1/E2701 PARTIAL LEVEL-09 FRAMING PLAN (PHASE-4)(SEQ#27)

PROJECT OWNER : HP NAREF, 1250 MARYLAND HOLDINGS 1 LP.
PROJECT DESCRIPTION : 1250 MARYLAND AVENUE
PROJECT ADDRESS : 1250 MARYLAND AVENUE, WASHINGTON, DC 20024
CONTRACTOR : IRON FABRICATION SERVICES, INC.

DWG DESCRIPTION : PARTIAL LEVEL-09 FRAMING PLAN (PHASE-4) (SEQ#27)

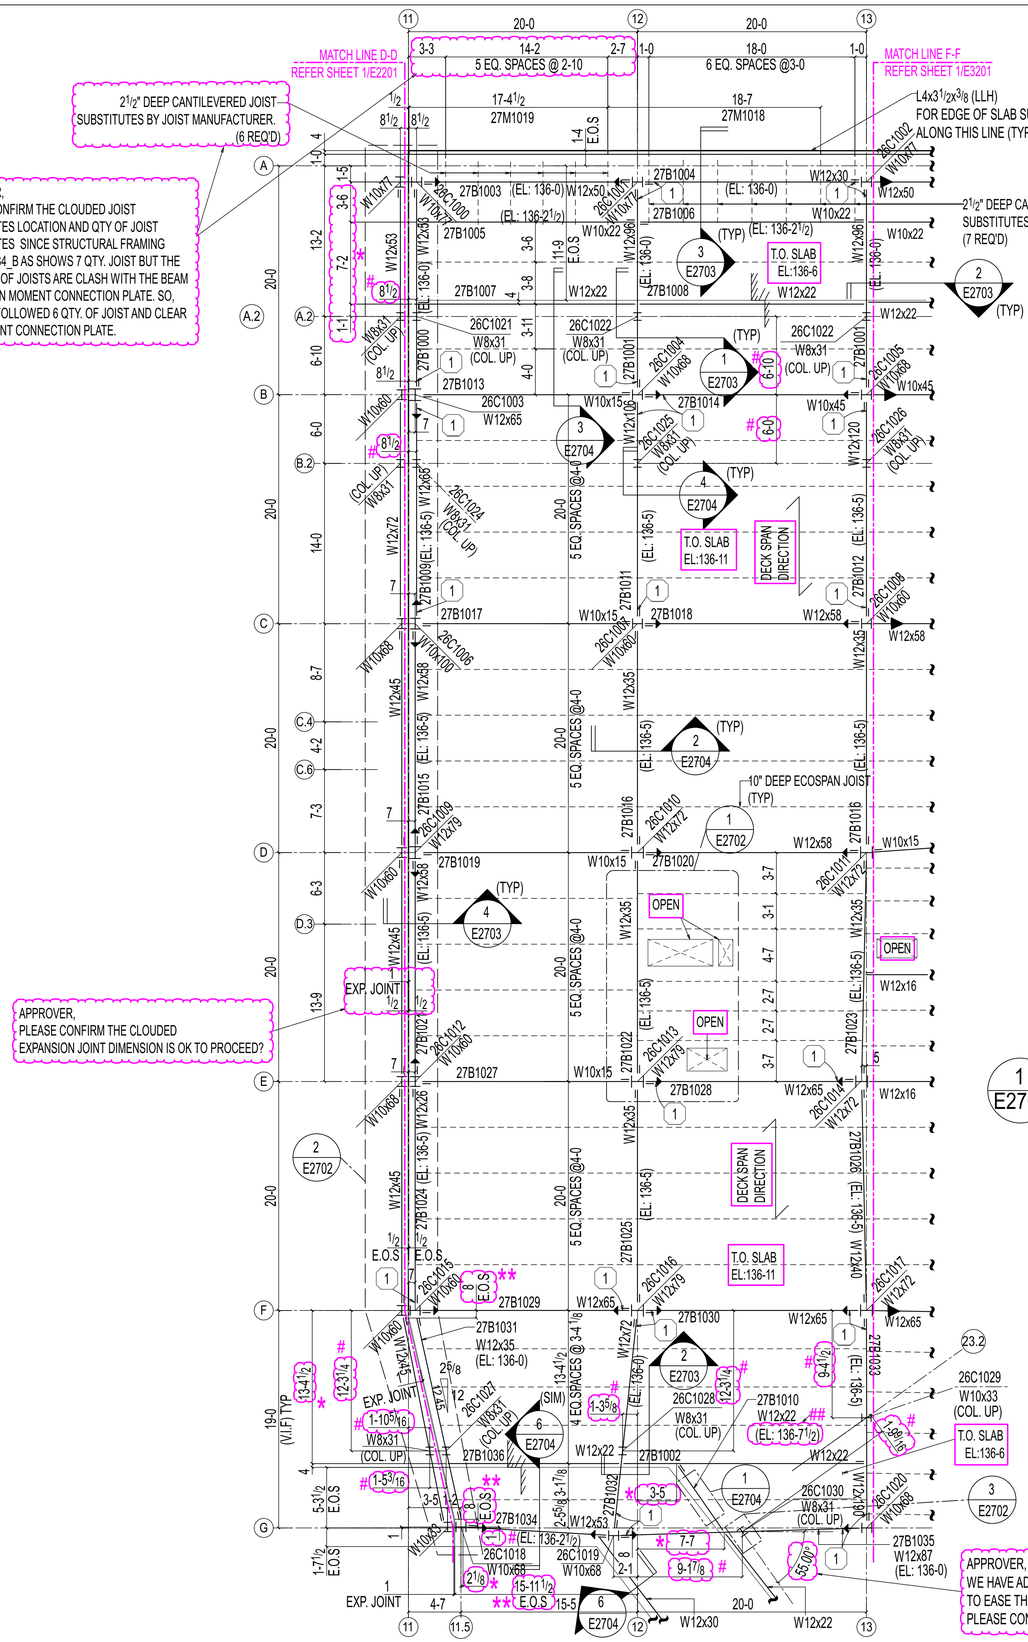
APPROVER,
PLEASE CONFIRM THE CLOUDED JOIST SUBSTITUTES LOCATION AND QTY OF JOIST SUBSTITUTES SINCE STRUCTURAL FRAMING PLAN 1/S134_B AS SHOWS 7 QTY. JOIST BUT THE EACH END OF JOISTS ARE CLASH WITH THE BEAM TO COLUMN MOMENT CONNECTION PLATE. SO, WE HAVE FOLLOWED 6 QTY. OF JOIST AND CLEAR THE MOMENT CONNECTION PLATE.

APPROVER,
PLEASE CONFIRM THE CLOUDED EXPANSION JOINT DIMENSION IS OK TO PROCEED?

★ -APPROVER,
PLEASE CONFIRM THE ALL CLOUDED BEAM LOCATIONS ARE OK TO PROCEED?

★★-APPROVER,
PLEASE CONFIRM THE EDGE OF SLAB DIMENSION IS OK TO PPROCEED?

-APPROVER,
PLEASE CONFIRM THE CLOUDED COLUMN LOCATION IS OK TO PROCEED?

-APPROVER,
PLEASE CONFIRM THE CLOUDED TOP OF BEAM ELEVATION IS OK TO PROCEED? SINCE WE HAVE ADJUSTED THE T.O.S EL. TO MATCH ADJUSCENT BEAM'S TOP.

APPROVER,
PLEASE CONFIRM ALL JOIST SPACINGS ARE OK TO PROCEED?

APPROVER,
THE STRUCTURAL PLAN SHOWS SOME BEAM LOCATIONS OFFSET FROM THE COLUMN CENTER. DUE TO FRAMING CONDITIONS AND CONNECTION REQUIREMENTS, WE HAVE ALIGNED THE BEAMS WITH THE COLUMN CENTER. PLEASE CONFIRM.

APPROVER,
PLEASE CONFIRM IF ANY STEEL IN THIS PROJECT REQUIRES FIRE PROOFING. WE ASSUMED ALL STEEL(LEVEL-09 THRU PENTHOUSE) IN THIS PROJECT WILL BE 1-COAT STANDARD PPG GRAY SHOP PRIMER.

APPROVER,
WE HAVE ADJUSTED THE COLUMN ROTATION TO 55° TO EASE THE BEAM END CONNECTION AT LEVEL- 10. PLEASE CONFIRM.

APPROVER,
PLEASE REVIEW ALL GRIDS AND GRID SPACINGS AND CONFIRM.
